**Greater Geelong Planning Scheme Amendment C372 and
Planning Permit Applications 662/2017 and 663/2017: 35 and 69-93 Hams Road and Barwon
Water Reserve, Waurm Ponds**

I wish to table this Expert Witness Report in respect of the abovementioned Amendment and Applications.

"Areas of Cultural Sensitivity" map for the subject property

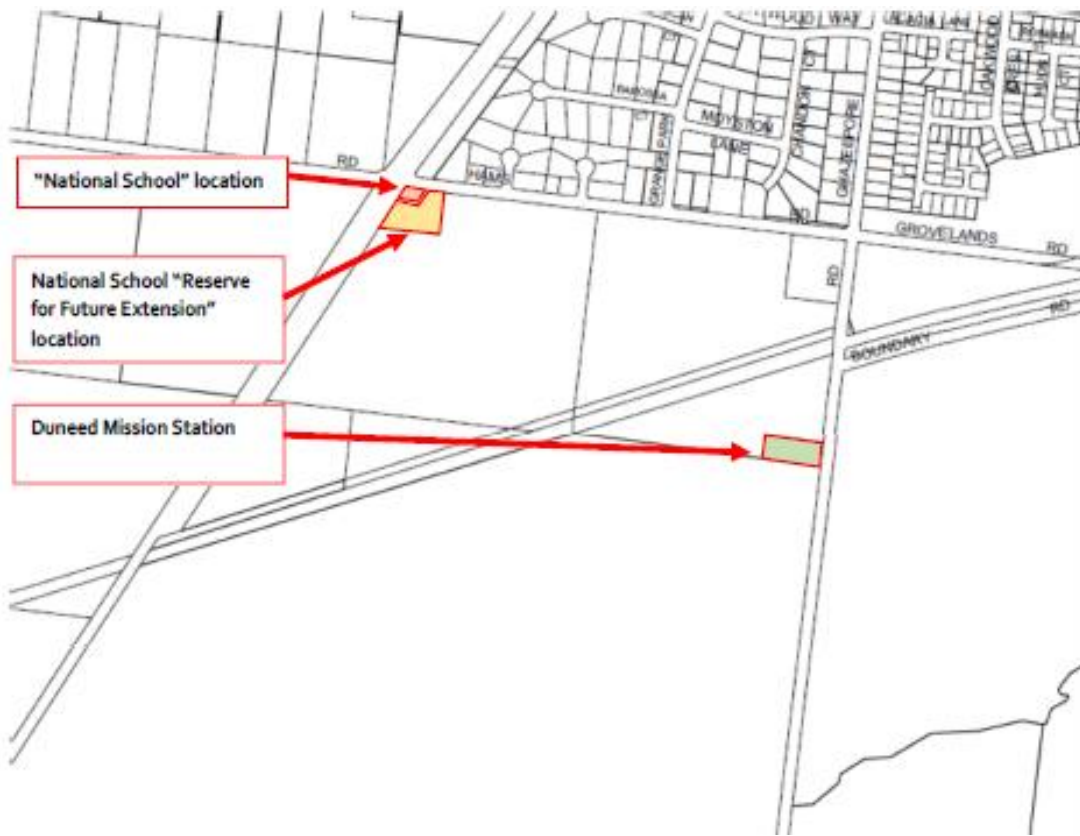
2.2 The veracity of the Cultural Heritage Report is questionable because it fails to disclose to the public, to the Wadawurrung (Wathaurung Aboriginal Corporation) and thus to the City of Greater Geelong, the complete cultural heritage values of significance of this subject land, wherein

- 2.2.1 obscures mention and discussion of the first National School funded in Victoria that was erected on the south-eastern corner of Anglesea Road and Hams Road, that was attended by children in Geelong as well as Wadawurrung children. The "school" is mentioned only by the on pages 5, 55 and 56, and raises major questions about the veracity and transparency of this report.
- 2.2.2 has no mention of the Duneed Mission Station property, located on Ghazeepoore Road, immediately adjacent to the subject land, that was occupied by members of the Wadawurrung community. The absence of mentioning this place, Geelong's equivalent to Coranderk Mission Station, raises major questions about the veracity and transparency of this report.

Waurn Ponds Station miki data 2017-2019

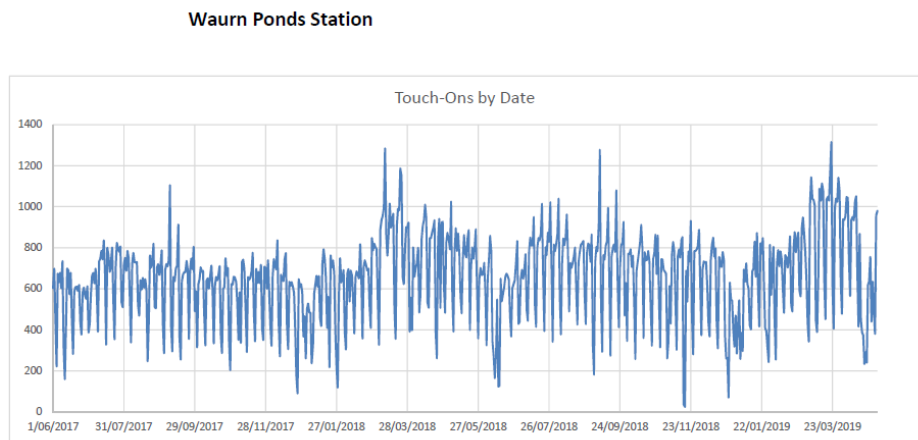
The Traffix projections fail to understand that Deakin operates a three trimester system rather than a two semester system. The three trimester system is not the conventional university summer school arrangement that typically occurs in Melbourne, but rather fully-accredited assessable units integral to a undergraduate or postgraduate degree.

Thus, 2017-2019 myiki data (below) from Waurm Ponds Railway Stations demonstrates constant 3 trimester use rather than normal university 2 semester use of this facility, and thus the intersection.

Extract of the *Armstrong Creek West Precinct Structure Plan (2012)*,

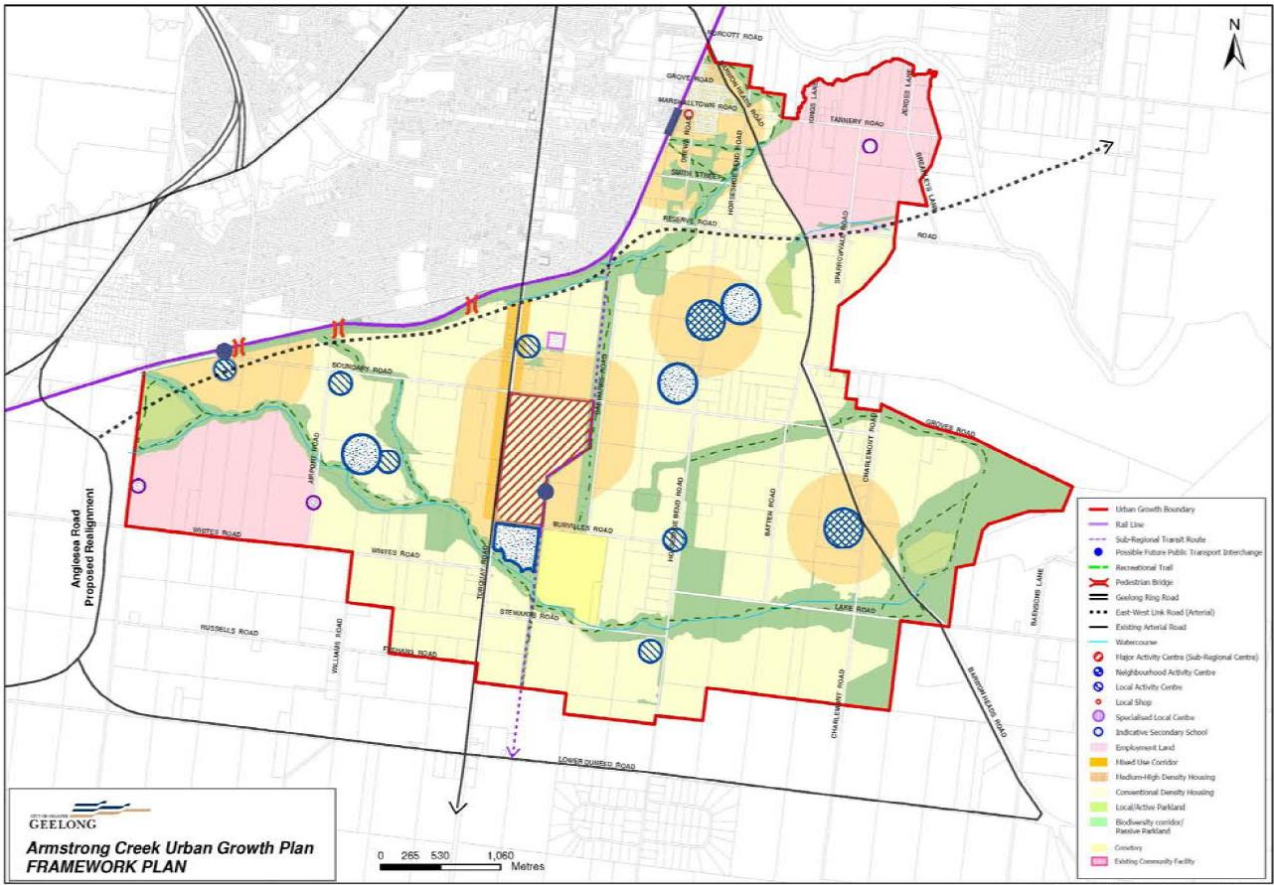
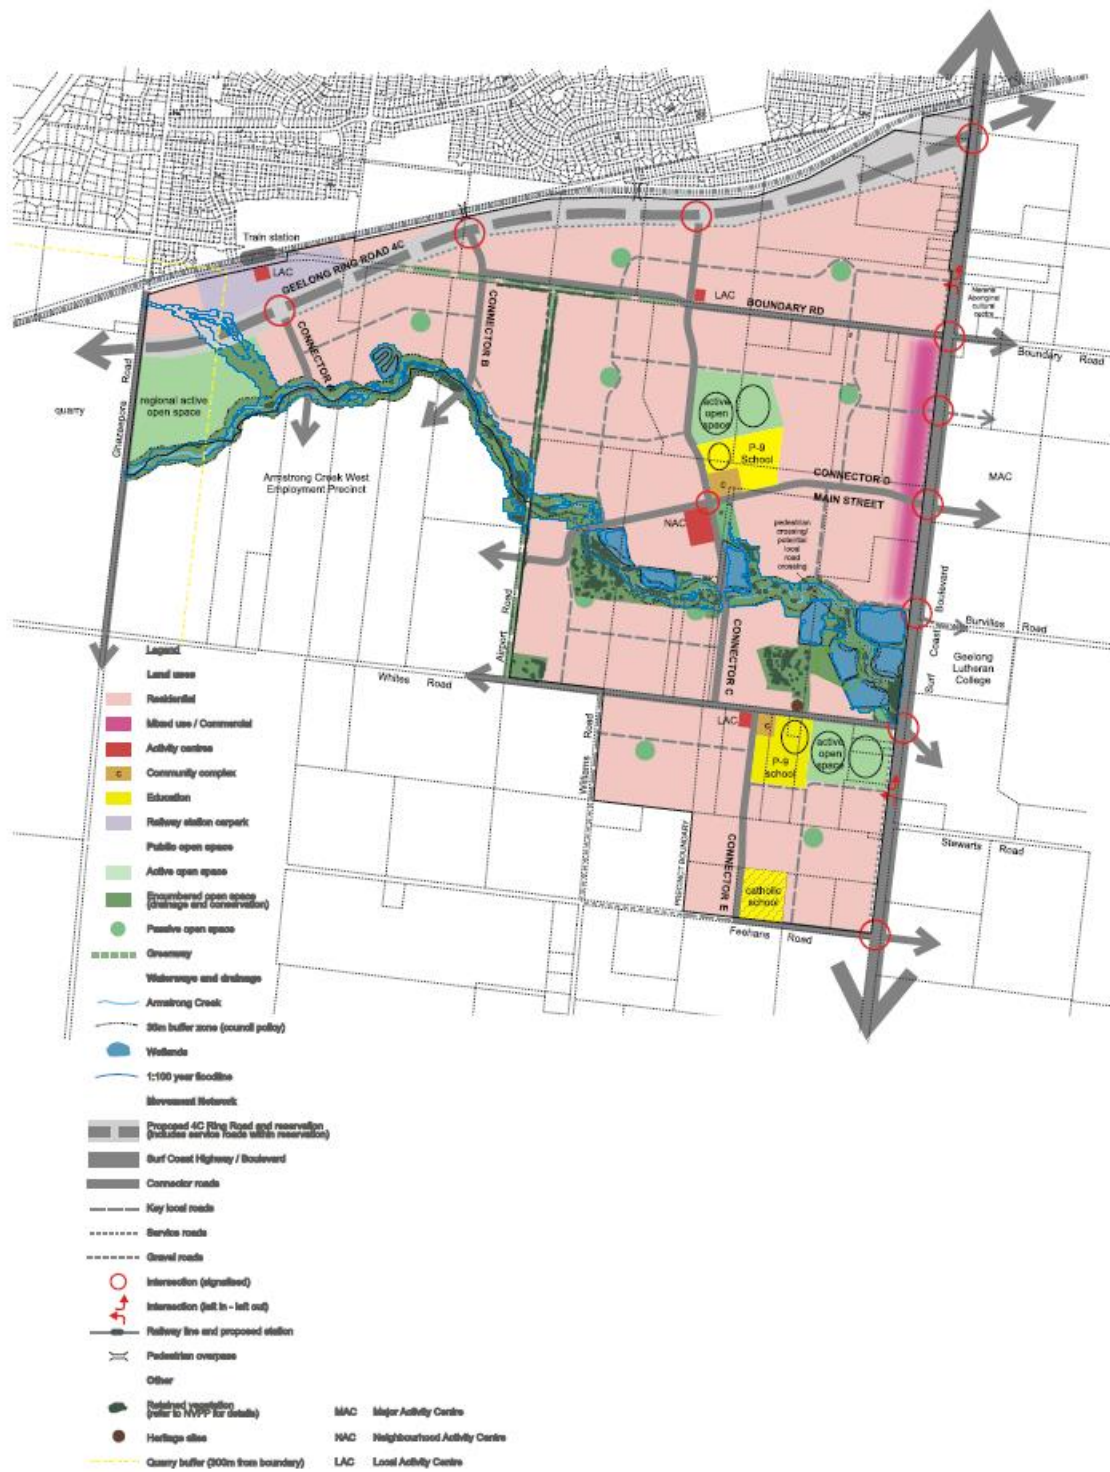
The Traffix projections fail to take into consideration the proposed Armstrong West Regional Active Open Space Park to be constructed on the south-east corner of Ghazeporee Road and Baanip Boulevard, as contained in the *Armstrong Creek West Precinct Structure Plan (2012)*, approved by Council. (See figures below) This designated 'Regional Park' will service both Armstrong West and Waurn Ponds residents, thus regional residents, and not simply Armstrong Creek West Precinct residents. The Park, involving 9 hockey/soccer fields and 18 tennis courts will host approximately 400 car parking spaces, with primary access onto Ghazepore Road. This facility, given the Waurn Ponds users, will escalate vehicle movement numbers on Ghazepore Road especially after school and on the weekends.
